DUKE POWER COMPANY

April 26, 1983

Re: McGuire Nuclear Station
Docket No. 50-369

Non-Proprietary Version of the
Attachment to the March 14, 1983
letter from H. B. Tucker to Harold R. Denton

Figure 1 RTD Bypass Loop Scoop Arrangement for Measurement of Hot Leg Temperature

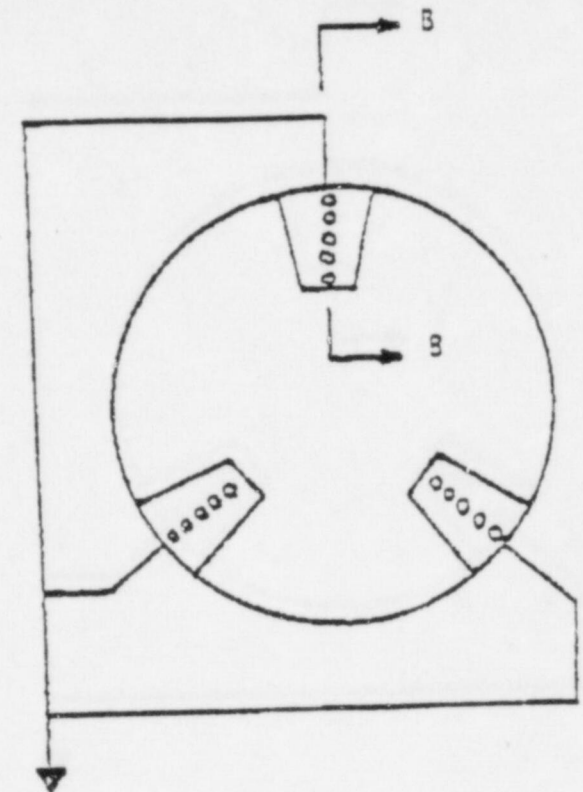
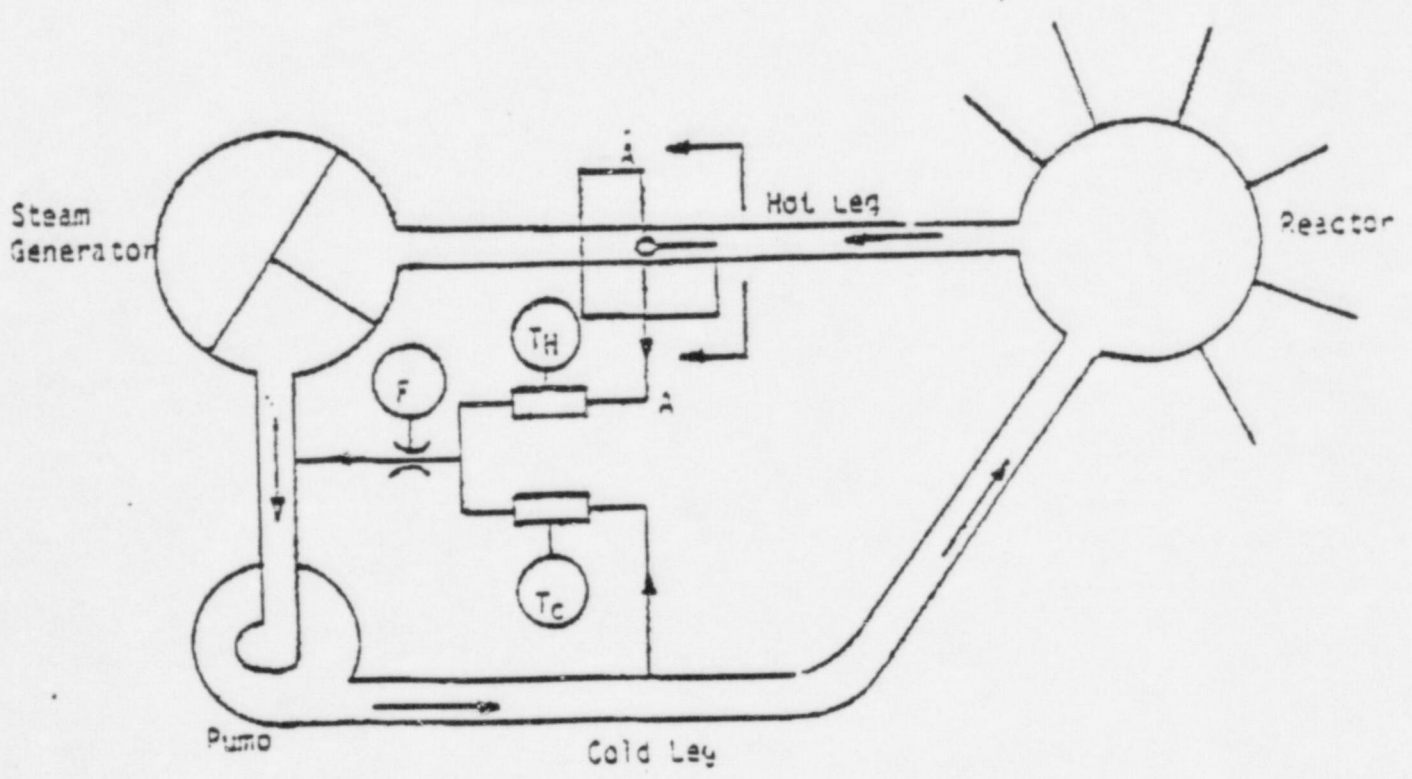
Provide justification for assigning ±1.2°F (Table 2) for the hot leg temperature streaming error.

A process measurement error has been incorporated into the reactor coolant system calorimetric flow measurement uncertainty to account for the steady-state temperature gradient in the hot leg, caused by incomplete mixing of the coolant flowing out of different regions of the core at different temperatures. Measurements obtained at a Westinghouse three loop plant established hot leg temperature gradients of []^{+a,c} in one loop and []^{+a,c} in another loop while at full power. To offset the effect of this temperature gradient, the hot leg temperature on subsequent plants (including McGuire 1) is measured on a bypass loop connected to the hot leg at three locations around the pipe circumference as shown on Figure 1. Each connection is provided with a probe, or scoop, which samples the coolant over a distance of 7 inches into the 29 inch inside diameter of the pipe. With this arrangement, the potential for a difference between actual average hot leg temperature and measured temperature is minimized.

Two factors are considered in the analyses of the measurement error: the temperature distributions that could be present at the scoops, and the deviation from balanced sample flows into the three scoops. With perfectly balanced sample flows, an evaluation of several possible hot leg temperature distributions has shown that the scoops will limit the measurement error to less than []^{+a,c} of the temperature gradient (i.e., []^{+a,c} for a maximum gradient of []^{+a,c}. With a conservative sample flow imbalance (50% flow in 1 scoop, 25% flow in 2 scoops) the evaluation has shown that the scoops will limit the measurement error to less than []^{+a,c} of the temperature gradient.

Calculations of the scoop branch line flow imbalances for several plants has shown that the estimated flows in most cases will range between perfectly balanced and a distribution of 40%-30%-30% resulting in smaller errors. In most plants with calculated flow imbalances, the upper scoop is expected to have the highest flow. When the results of the three loop plant test are considered (top of hot leg was hotter than the bottom), the measured hot leg temperature is more likely to be hotter than the average hot leg temperature, leading to a conservatively low calorimetric flow measurement. Since there are uncertainties in the temperature streaming distributions and magnitudes, the allowance for the temperature streaming measurement uncertainty has been set conservatively at []^{+a,c} regardless of the scoop flow distribution.

For McGuire Unit 1 the analysis of the scoop branch lines has shown that the flows should be reasonably balanced. Therefore, the []^{+a,c} allowance for temperature streaming is additionally conservative.
